## COUNCIL ASSESSMENT REPORT

<b>Panel Reference</b>	<b>PPSSCC-221</b>
<b>DA Number</b>	DA 1154/2021/JP
<b>LGA</b>	The Hills Shire Council
<b>Proposed Development</b>	A 6-8 Storey Commercial Office Building with Ground Floor and Roof Top Food and Drink Premises
<b>Street Address</b>	7 Maitland Place Norwest
<b>Applicant</b>	Haitchin Commercial Pty Ltd
<b>Consultant/s</b>	Dowling Urban – Planner Turner – Architects Naturally Trees – Arborist Eco Logical Australia - Flora and Fauna Assessment City Plan – BCA Assessment Vista Access Architects – Access Report AT& L – Engineers EI Australia – Geotechnical Engineer and Contamination Report SESL Australia – Soil Volume Calculation & Design JHA Services – Green Star Report, Noise Impact Assessment Arcadia – Landscape Architect Elephants Foot – Waste Management Plan Craig & Rhodes – Site Survey TTPP - Transport Impact Assessment
<b>Date of DA lodgement</b>	9 February 2021
<b>Number of Submissions</b>	One

<b>Summary of key submissions</b>	<ul style="list-style-type: none"> <li>Traffic and parking concerns during construction</li> </ul>
<b>Report prepared by</b>	Cynthia Dugan – Principal Coordinator Development Assessment
<b>Report date</b>

Figure 3: Development with compliant setbacks

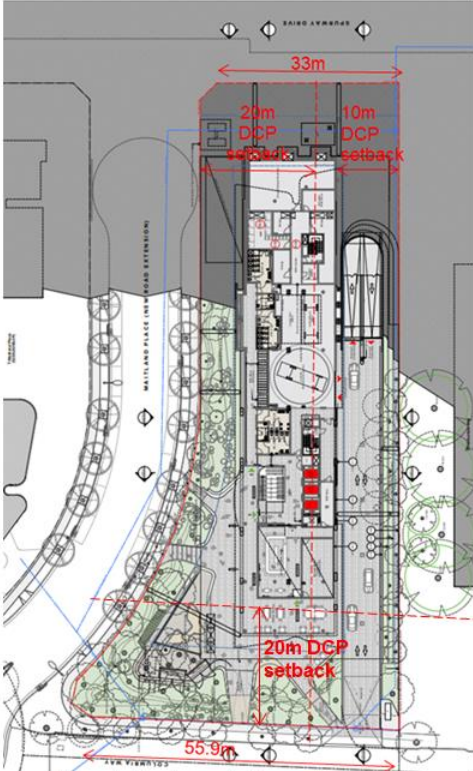
The proposal is located on lot 11 of an approved subdivision under development consent 2267/2018/ZA. The irregular shaped lot has a width of between 33m – 55.9m. A development with a compliant scheme cannot be achieved on this lot. Refer to Figure 3 below.

The Design Review Panel has provided the following comment in relation to the setback variations:

*“The Panel acknowledges the narrow site width resulting from the modified subdivision plan and relocation of the proposed road further east. This has implications on the proposed street setbacks. The proposed setback extension of Maitland Place may be acceptable subject to Council’s consideration and clarification of landscape detail with Council’s Landscape Assessment officer.*

*The Panel does not accept that a 10m is an acceptable setback for Columbia Way...the Panel considers that the setback to Columbia Way should be a minimum of 13.5m, to better align with the character of existing setbacks along the northern side of Columbia Way (ranging from 16 – 28m) and allow for enhancement of the role of Columbia Way as an accessible and well-utilised pedestrian and vehicle thoroughfare in the future. This increased setback would “future-proof” the development on the site against any potential changes to the alignment or width of Columbia Way, if the Council were to determine this as being necessary as a result of traffic modelling, infrastructure analysis and precinct planning for the Norwest Strategic Centre which is currently underway”.*

Figure 4: Design Diagram indicating landscape buffers along street frontages

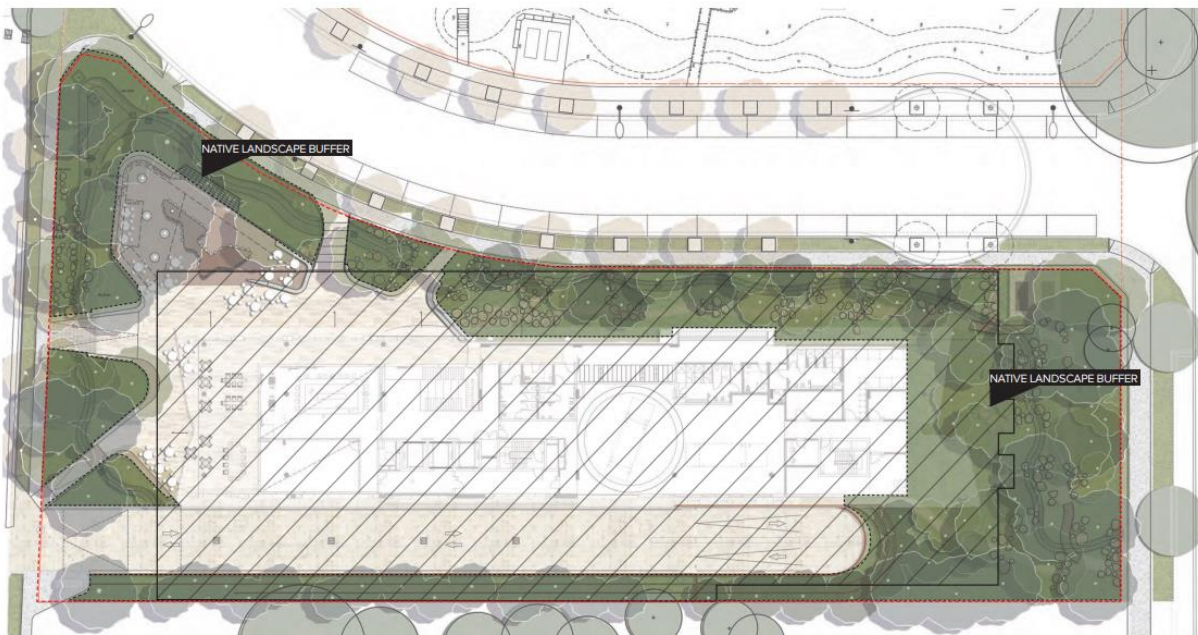
As a result of these recommendations, considerable changes have been made to the landscape design along the Maitland Place and Columbia Way frontages with a substantial increase in native landscape buffer along all frontages. The proposal now comprises 2,300m<sup>2</sup> native and indigenous buffer planting and 121 new trees and established tree canopies. Refer to Figures 4 and 5 below.
